Door Hinge Assembly

SPC_045A

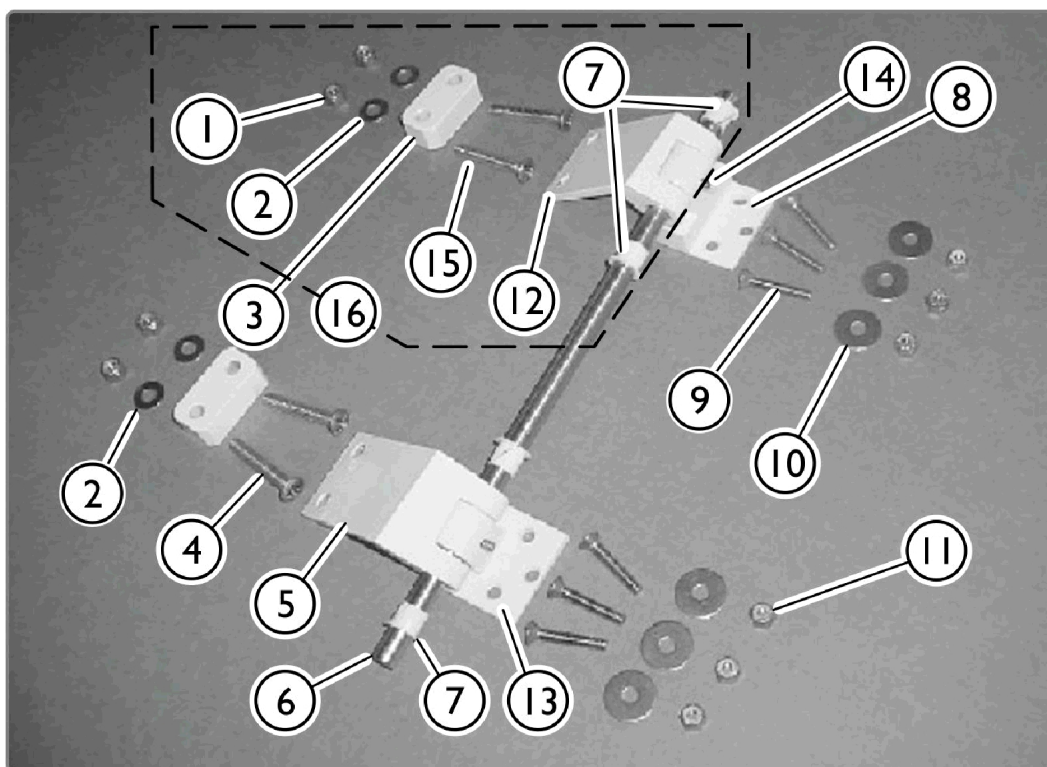
NOTE: A - IHPAR3615A (one piece hinge pin) replaces 2 of IHPAR3615 (single hinge pin).

B - If Tub was manufactured before 09/22/17, entire Kit item #16 part number 60001324 must be ordered. Includes items 1, 2, 7, 12 and 15. Item 12 and 15 are not sold separately. Item 15 Screws should be torqued to 45-60 in-lbs.

For item #12 and 15 order item #16 part number 60001324 as a replacement.
